IN THE MATTER of Ashbourne (FTAA-2507-1087)

JOINT STATEMENT OF EXPERT WITNESSES:

STORMWATER AND GROUNDWATER

4 March 2026

Figure 1: Groundwater Level Synthetic Hydrograph Using WRC Bore 64_831 for Site 25-P3

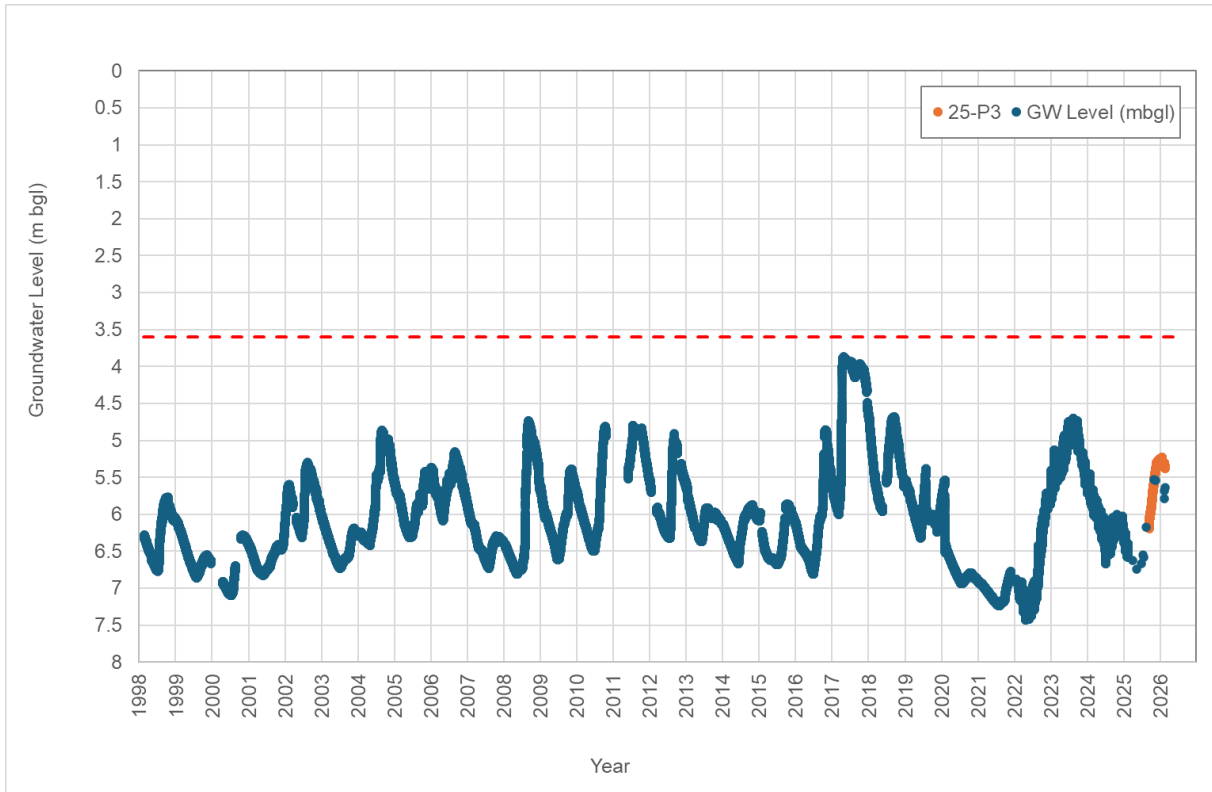
10. CH states that under the monitored groundwater conditions under the top of Basin A have reached 5.3m below ground level (mBGL). The modelled level of 3.6mBGL is 0.3m above any groundwater levels that have been observed in the last 30 years based on the synthetic hydrograph. JW would expect that, in a 100yr record, this would be similar to the highest recorded level.

11. CH and JW agree that the 3.6mBGL used as an initial groundwater level is appropriate for the mounding assessment for 10yr and 100yrs ARI event.

Based on this synthetic hydrograph (Figure 1), WGA concludes that groundwater levels at 25-P3 seldom rise above 4.5 m bgl. The synthetic record indicates groundwater only rose above 4.5 m bgl, during one extended period over 30-year record, occurring in 2017. During this period groundwater levels rose to a maximum level of 3.9 m bgl. No other individual storm events or seasonal combination of rainfall events resulted in a level of 4.5 m bgl being exceeded. Therefore, the most conservative groundwater level used in the groundwater mounding assessment (3.6 m bgl) is 0.3 m above the highest groundwater level derived from the synthetic record over a 30-year period.

Title
**PROPOSED STORMWATER
 BASIN CATCHMENT
 OVERVIEW PLAN**

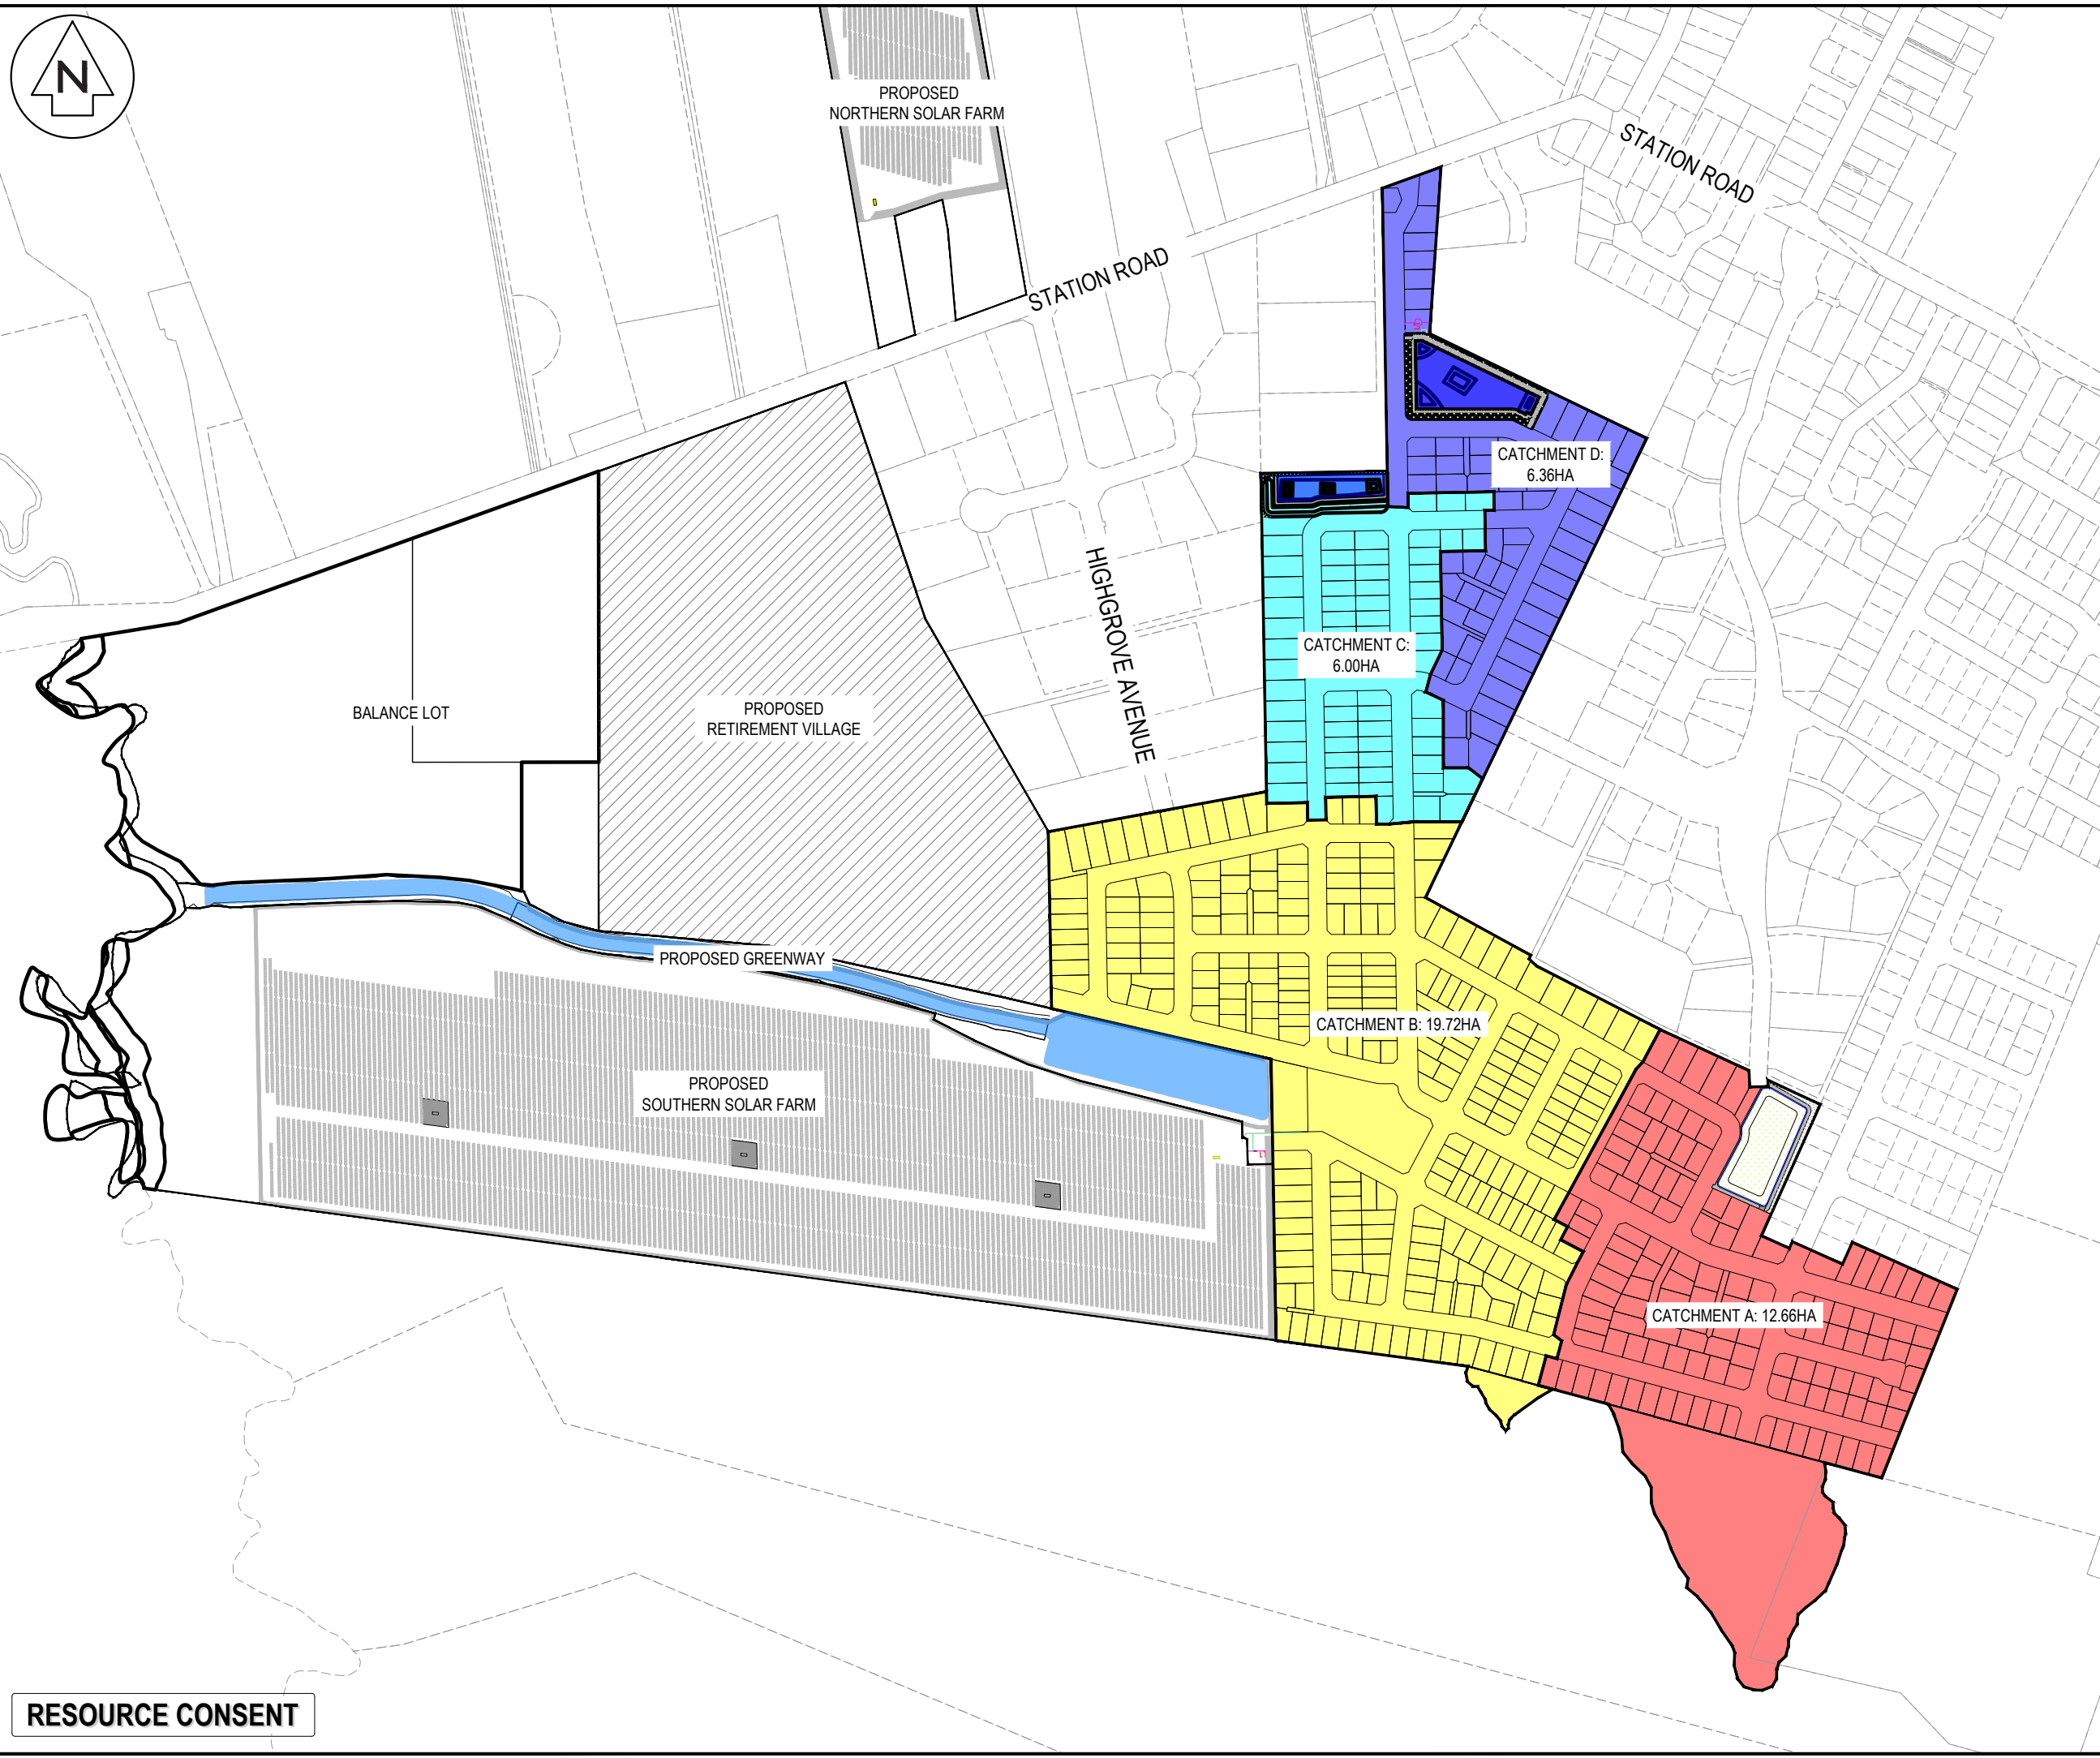
18. DM and WM refer to Maven memo responding to Minute 16 (dated 27 February 2026). The disposal is not necessary within the lots and roads in Catchment A due to the redundancy within Basin A. Catchments are shown on Maven plan C420 revision D (attached as **Appendix 2**). See also answer to Question 1 above.
